APPEAL SUMMARY

Status: Decision Rendered - Reconsideration of IDs 18962 and 19041

| Appeal ID: 20508 | Project Address: 631 SE Taylor St |
| Building/Business Name: The Rose Apartments | Fire Sprinklers: Yes - proposed throughout |

| W | 11 | 2 HOUR RATED INTERIOR WALL |

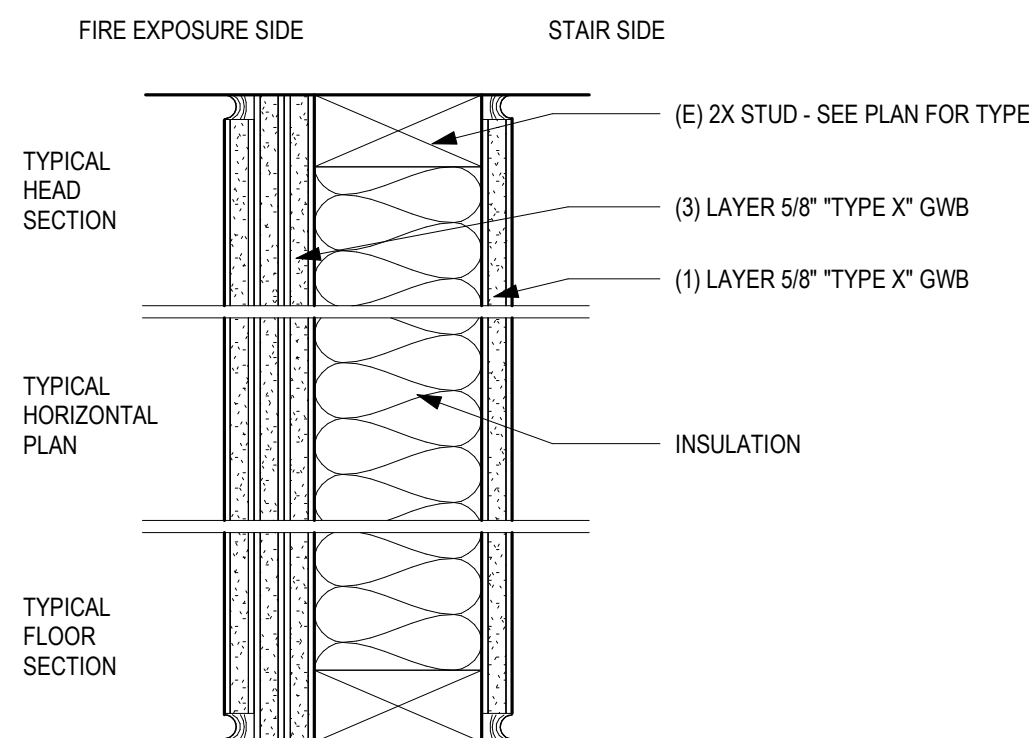
Seven details are analyzed for fire resistance. All show their target fire resistance with the exception of the right-hand side of Detail W11 on Drawing A001. However there is insufficient fuel in the stairway enclosure to challenge the 1-hour construction that is provided on that side. See the following analysis.

Drawing A001 Detail W11

This detail shows a typical light wood framed wall with three layers of 5/8 inch Type X gypsum wallboard (GWG) on the left-hand side and one layer on the right-hand side.

X 2 1/2 HOUR RATED EXISTING INTERIOR WALL
FIRE : IBC RESOURCE A TABLE 1.3.2
ITEM# W-4-W-42
ACOUSTIC : N/A

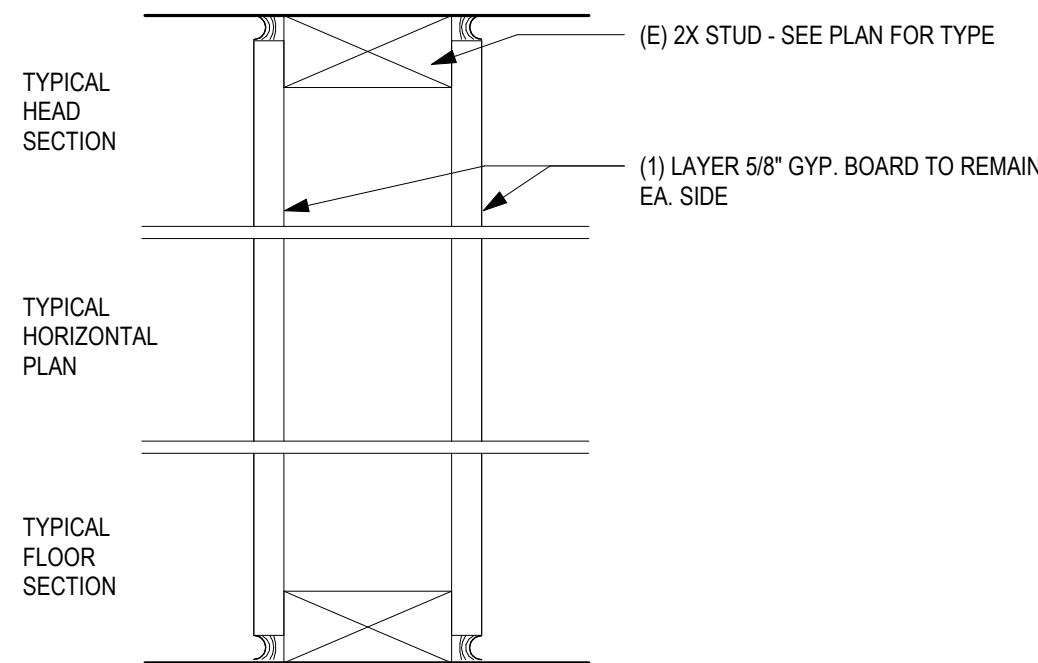
Drawing A003 Detail X2

The detail shows lath and plaster over a typical light wood frame wall. This assembly is assigned 30 minutes of fire resistance based on comparison. See OSSC (2014) 703.3 4. and *International Existing Building Code* (IEBC), 2012 Edition, Resource A, Table 1.3.2, Item Code W-4-W-42.

F11 1 HOUR RATED FLOOR ASSEMBLY BENEATH HISTORIC CABINETS

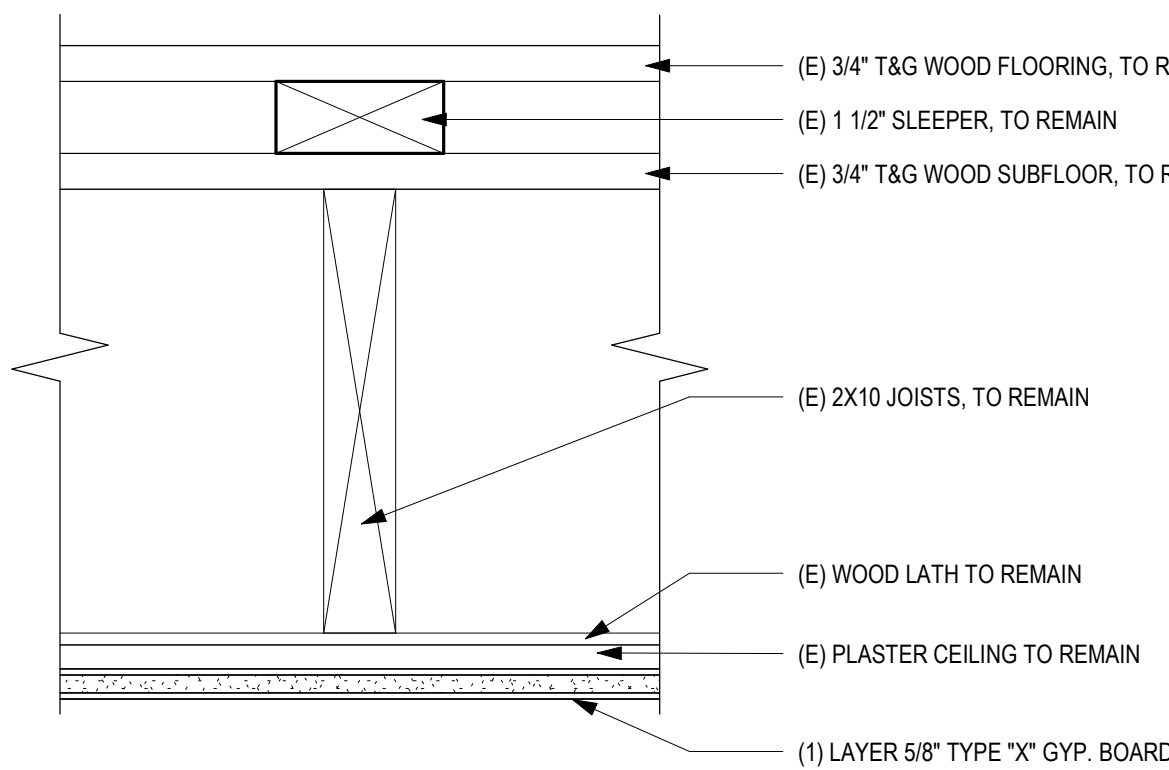
F8, F11 and F12 - 1-hour horizontal assemblies. Most of the existing floor-ceiling assemblies are existing to remain with an additional layer of 5/8" Type "X" gyp. board added to the underside of the existing lath and plaster ceiling. Due to limited funding for the project, the Owner wishes to retain the existing lath and plaster finish where possible in lieu of stripping it and refinishing with gyp. board. The gyp. board overlay provides 40 minutes of fire resistance per OSSC Table. 722.6.2(1). The existing wood joists achieve 10 minutes per Table 722.6.2(2). The existing lath and plaster ceiling provides an additional 15 minutes per IEBC Resource A Table 1.5.1 Item F.R.I-11. The ratings in Resource A are based in fire science and testing data. The 2014 OSSC does not recognize the IEBC, however many states have adopted the IEBC in lieu of Chapter 34, and the 2018 IBC eliminates Chapter 34 and refers to the IEBC instead. The IEBC is a legitimate international code published by the same recognized body that publishes the IBC and should therefore be considered an appropriate alternative source for evaluating existing conditions.

Drawing A004 Detail F11

F12 1 HOUR RATED FLOOR ASSEMBLY

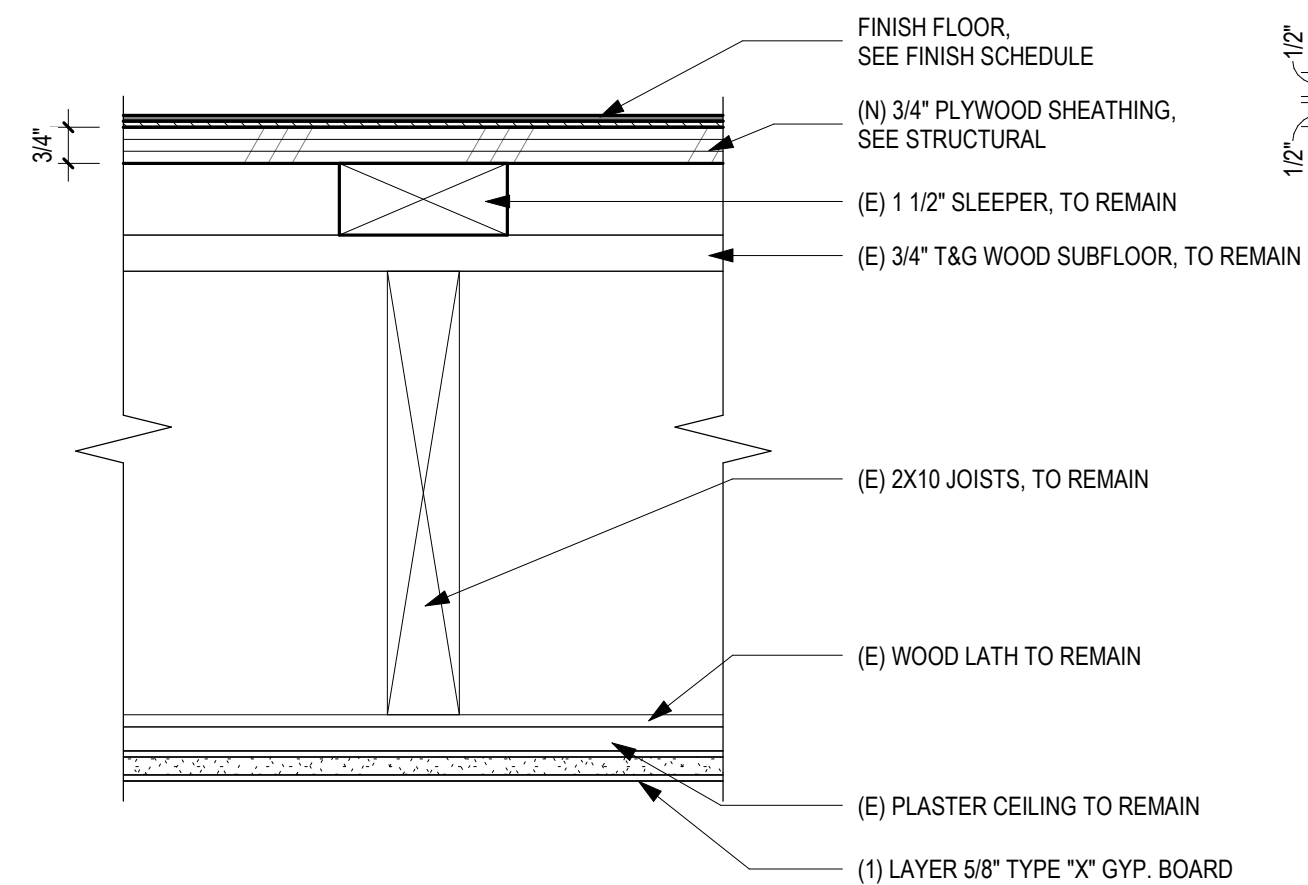
Drawing A004 Detail F12

F8 1 HOUR RATED GROUND STORY FLOOR ASSEMBLY, TYP ABOVE BASEMENT

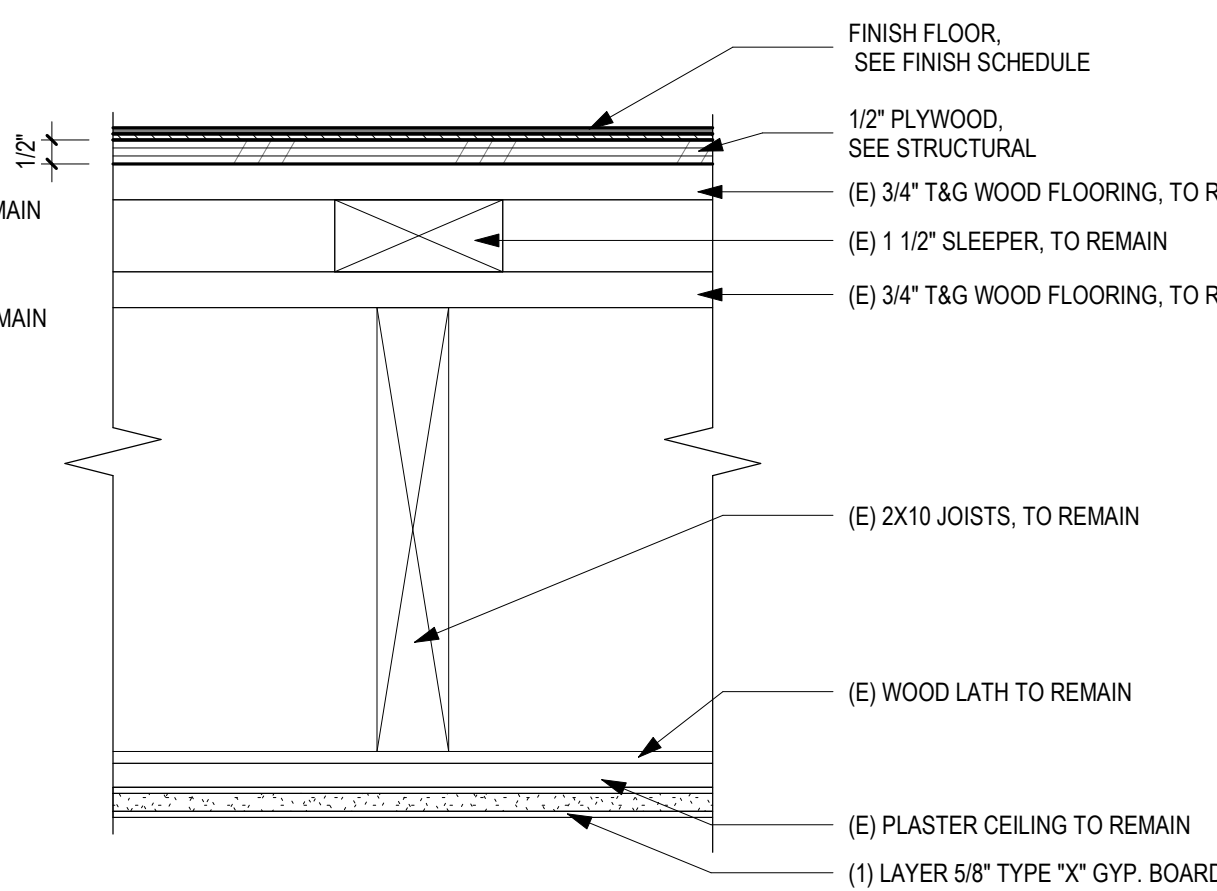
Drawing A004 Detail F8

5
A311
ENCLOSED NORTHEAST EXIT STAIR SECTION
1/2" = 1'-0"

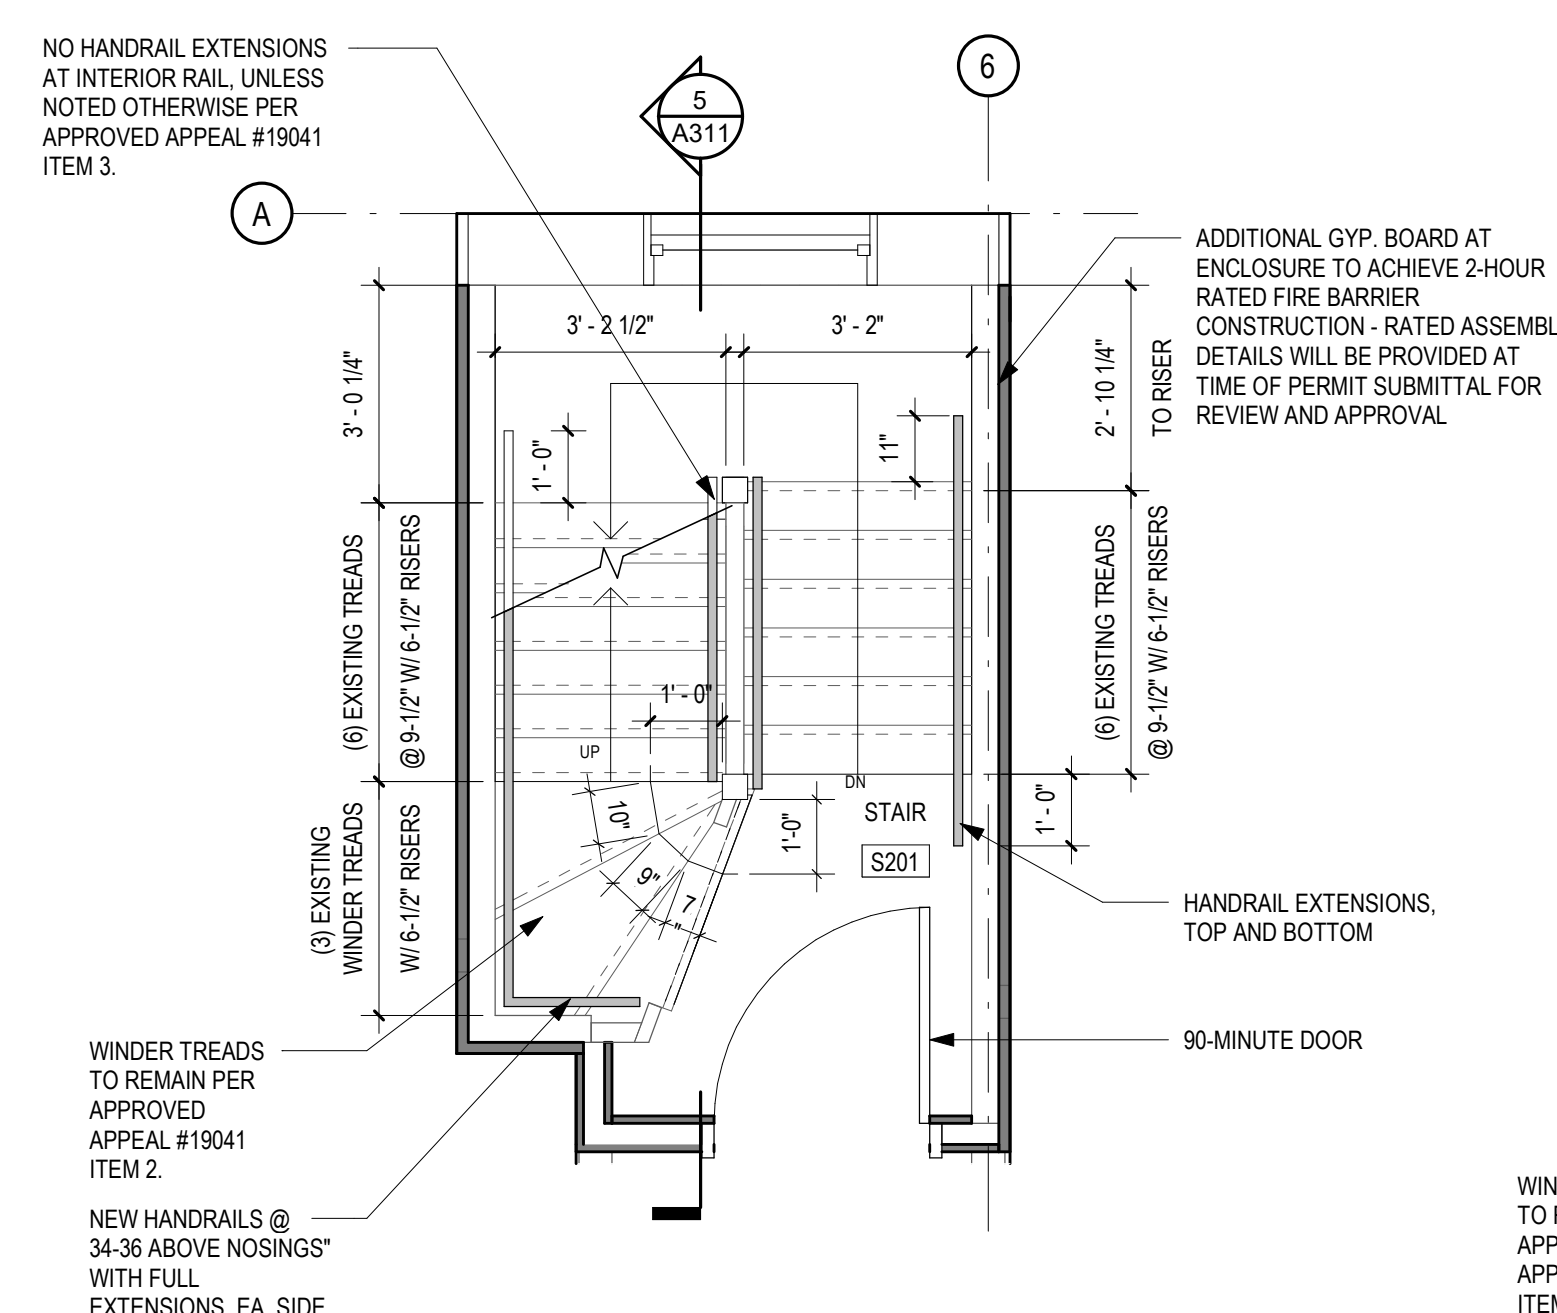
See detail 5/A311.

| Reason for alternative | This appeal is in response to a Life Safety checksheet item. The existing winder treads were approved by Appeal #19041, Items 3 and 4. That appeal included details of the existing stairs in their entirety, including existing head height. This information was provided at the time of the original appeal at the request of the Appeal Board. |

The existing northeast and northwest stairs are original to the building and were permitted at the time of construction in 1910. There is not room within the existing exit stair enclosures to provide more headroom over these treads. Chapter 34 allows materials and systems already in use in compliance with approvals in effect at the time of their erection to be permitted to remain in use unless determined to be unsafe.

- 1. Level 1 accessory occupancies: Granted provided non-separated occupancies are limited to levels 2 and 3 only, to be verified at time of plan review.**
- 2. Four alternate fire rated assemblies with engineering analysis: Granted as proposed.**
- 3a. Existing stairs with increase in minimum allowable riser height to 8.5 inches: Granted as proposed.**
- 3b. Existing stairs with decrease in minimum allowable tread depth to 9.5 inches: Granted as proposed.**
- 4. Existing stairs with reduction in minimum required landing width: Granted as proposed.**
- 5. Existing stairs with reduction in minimum required headroom: Granted as proposed.**
- 6. Door encroachment: Granted as proposed.**

4 NORTHEAST EXIT STAIR SECTION APPEAL ITEMS #3 AND #4
GA5 1/4" = 1'-0"

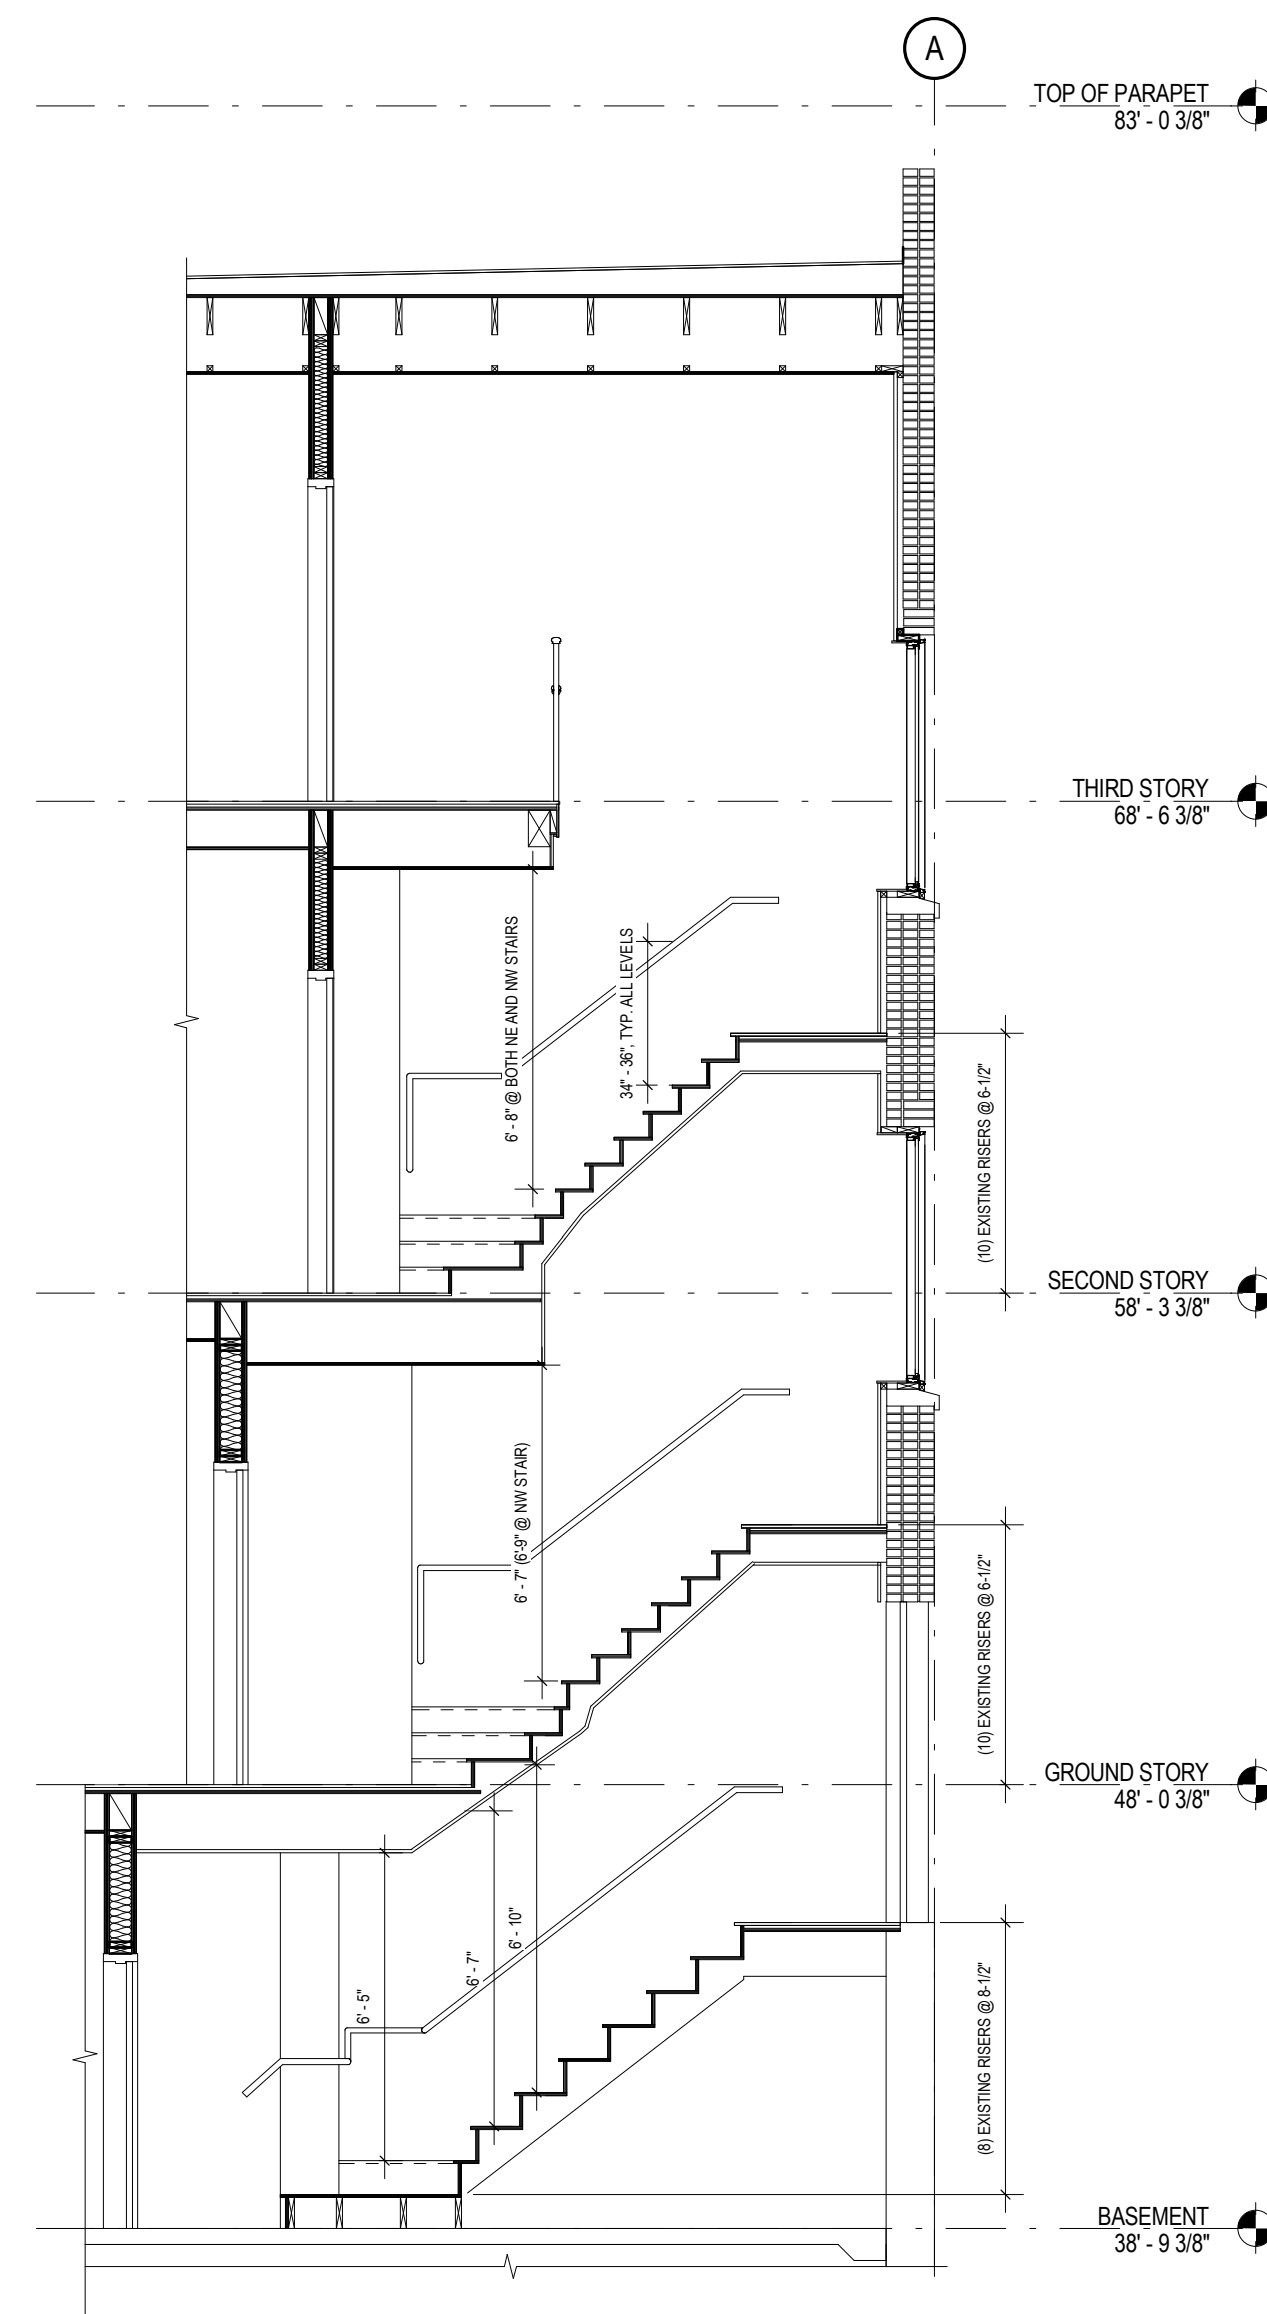
Reason for alternative ORIGINAL APPEAL TEXT: The existing northeast and northwest stairs are original to the building and were permitted at the time of construction in 1910. There is not room within the existing exit stair enclosures to replace the winder treads with treads that meet current requirements. Chapter 34 allows materials and systems already in use in compliance with approvals in effect at the time of their erection to be permitted to remain in use unless determined to be unsafe. In addition to being permitted at the time of construction, the winder treads have been approved by two previous building code appeals dated 8/8/74 and 1/27/88.

RECONSIDERATION TEXT: The existing northeast and northwest stairs are original to the building and were permitted at the time of construction in 1910. There is not room within the existing exit stair enclosures to replace the winder treads with treads that meet current requirements. Chapter 34 allows materials and systems already in use in compliance with approvals in effect at the time of their erection to be permitted to remain in use unless determined to be unsafe. In addition to being permitted at the time of construction, the winder treads have been approved by two previous building code appeals dated 8/8/74 and 1/27/88.

The project scope is taking all available measures to bring these stairs as close to compliance as technically feasible. The existing stair enclosures will be made safer than they are currently by ensuring the enclosure assemblies meet the requirements for 1- and 2-hour construction. The rated assembly details will be provided with the permit submittal for review and approval by the plans examiner. New rated doors into the stair enclosures and also rated doors exiting to the Egress Court will be provided. A noncompliant opening in Stair S101 will be filled in with 2-hour rated construction. A landing at the bottom of the basement Stair S001 will be provided where there is none now. All lighting in the stair enclosures will be replaced to ensure compliance with Section 1006. Handrails will be provided on both sides with extensions that comply to the extent possible (refer to related Appeal Item #4).
